P 529597

A REPAIR

ON-SITE SEWAGE DISPOSAL SYSTEM HOWARD COUNTY HEALTH DEPARTMENT BUREAU OF ENVIRONMENTAL HEALTH

ADDRESS: 13516 Argo Drive PROPERTY OWNER: Schannie

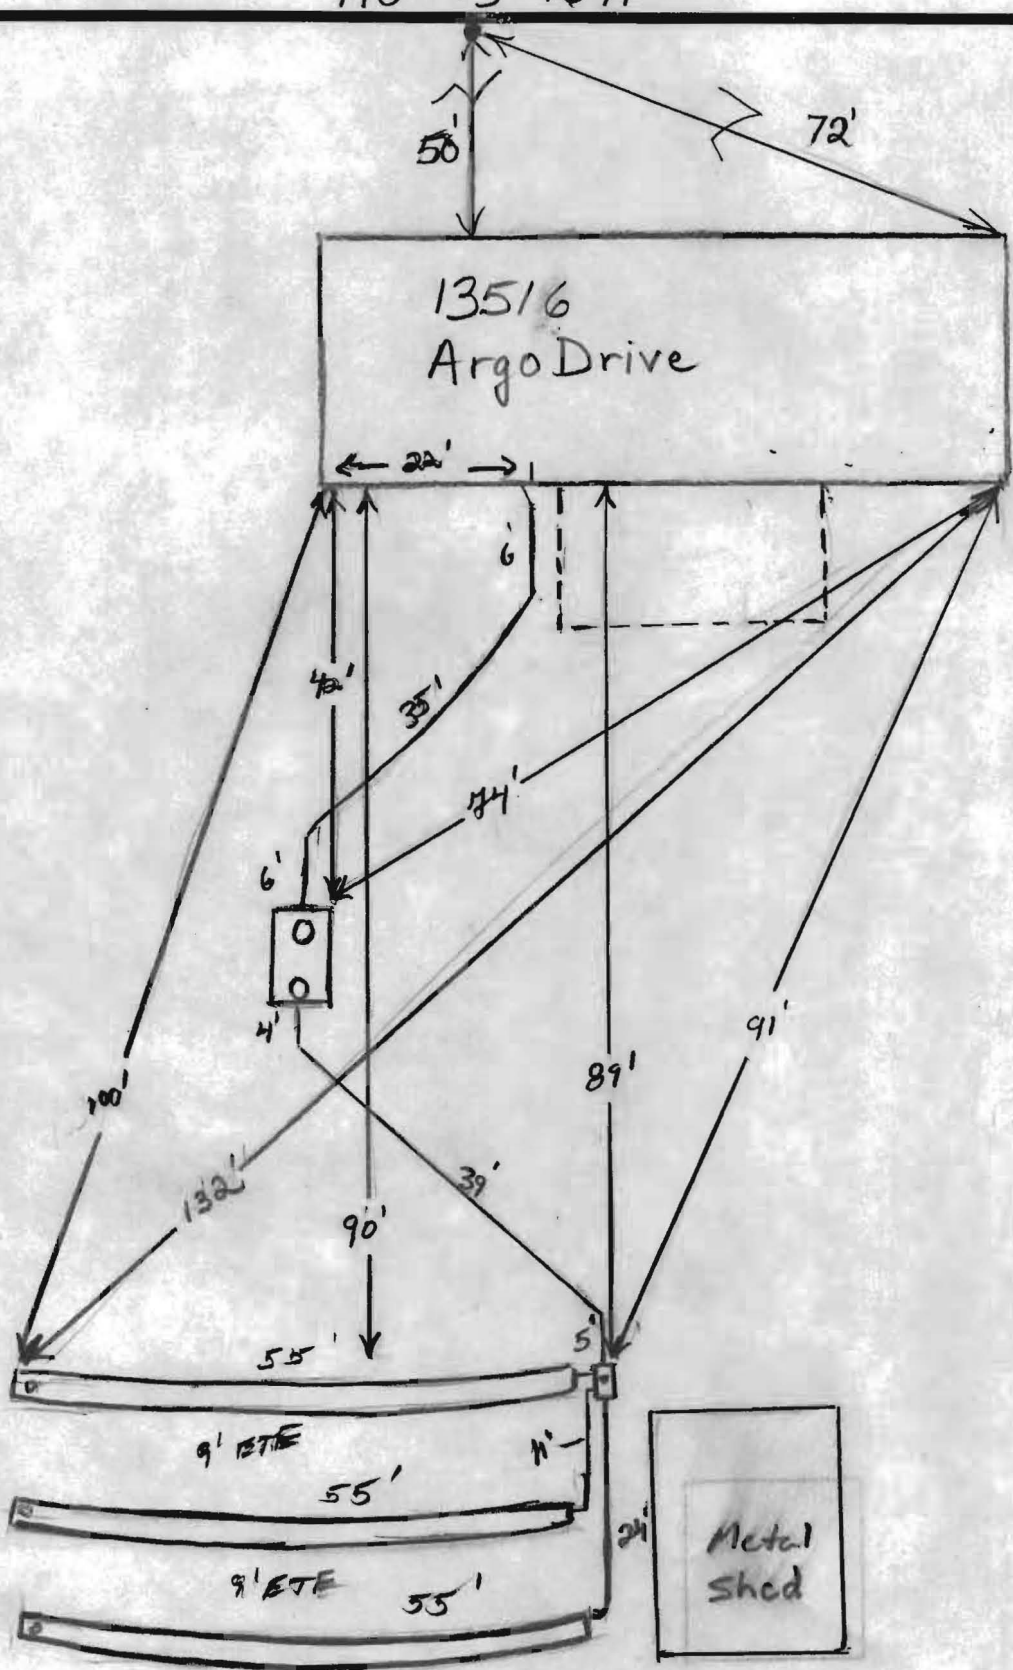
11/14/08 Install
three 55' trenches
on contour just
below perc test

hole A. Start the trenches close to the metal shed. The
property line is 70' from the shed. Install a new tank
outside of the 100' well radius. Pump out and abandon
INSTALLATION the old tank and the drywell (BB)

12/3/08 All system components installed per design. Finishing up
last trench row. Top trench inlet @ 3' bottom 4'. reed
2 trenches inlet @ 18" bottom @ 3'. OK to cover all work
when finished. (SW) Ex S.T. and D.W. pumped and collapsed.
